Justification for Class II permissive change – AT&T1430
FCC ID: EW780-5125-H01 & EW780-5125-B01

The description Difference Between AT&T1430 and AT&T1430MK2

2. Handset Block Diagram

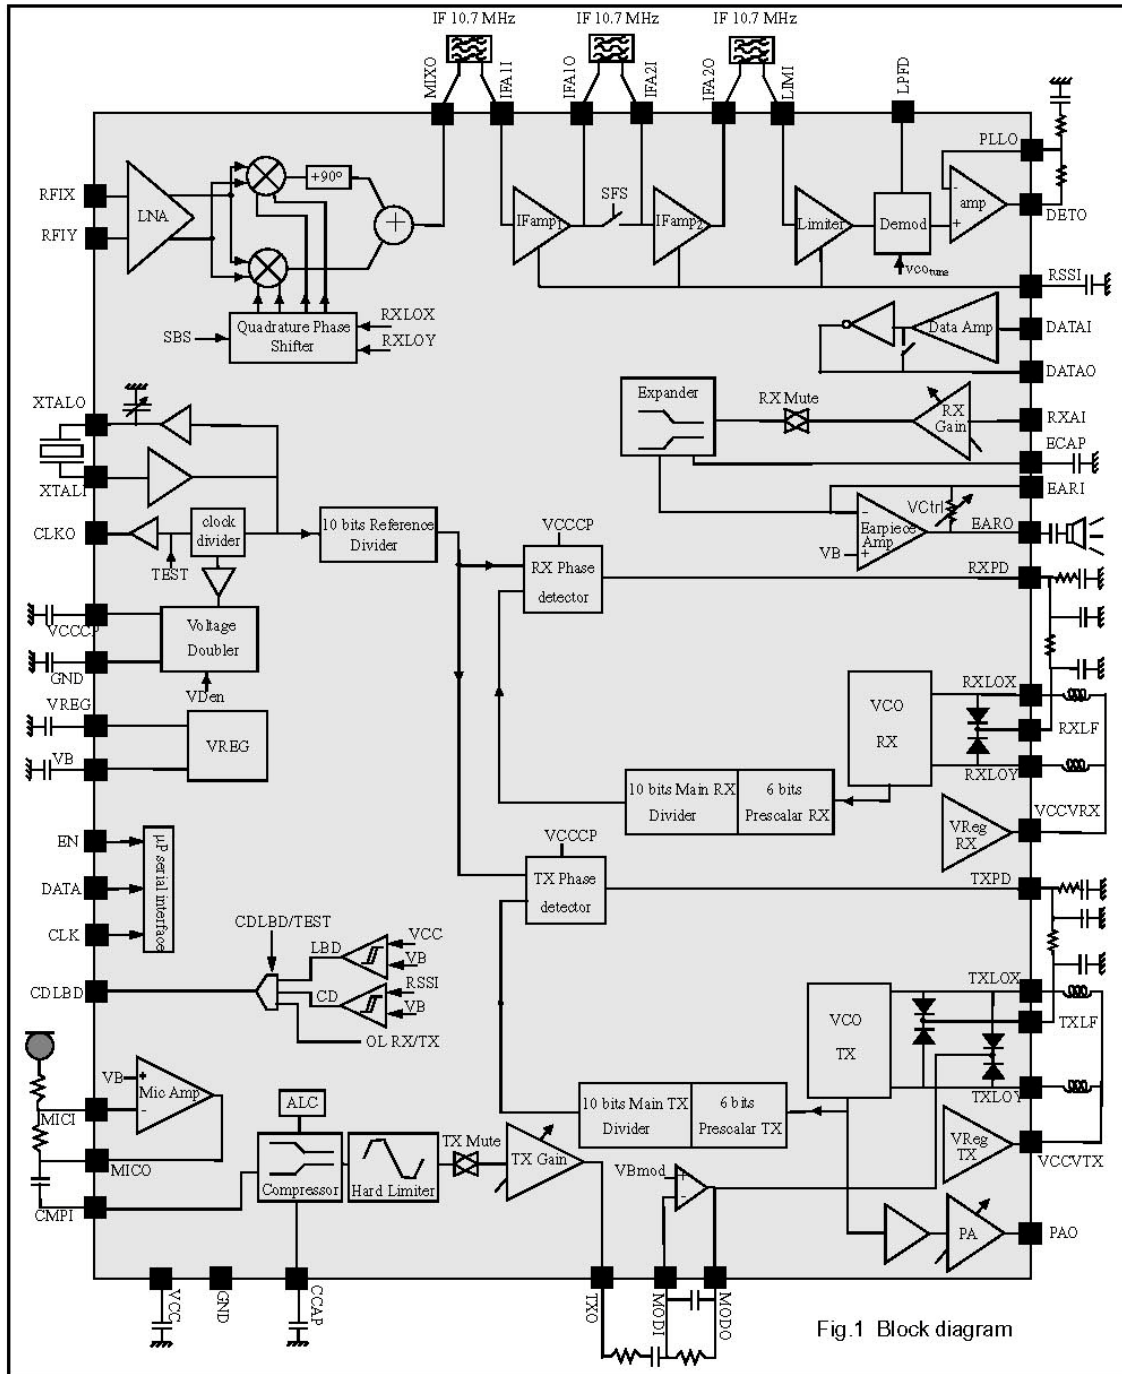
- 1) Tx – using discrete components to replace LC filter is not considered as major change.
- 2) Rx – the integration of Rx PLL & VCO to RF IC U3517B is a planned migration that keeps all RF stages & frequencies remain the same. This will not affect the intended radiation & the unintended radiation was tested & verified to be within FCC limits.

AT&T1430	AT&T1430MK2
RF section		Base on MK1,details of modification: 1. Integrated the external RX PLL and RX VCO into RF IC U3517B. 2. Canceled 2.8V Regulator. 3. Used U3517B to replace U3515. 4. Discrete components BPF in stead of 915MHz LC filter.
Audio circuit		1. Cancel 5V LCD, use 6V LCD. 2. Added a control circuit for RF 2.8V supply. (Q6,Q7)
MCU circuit	same	same
Power management		1. New DC voltage arrangement--- use 3.0V regulator to replace 2.5V.
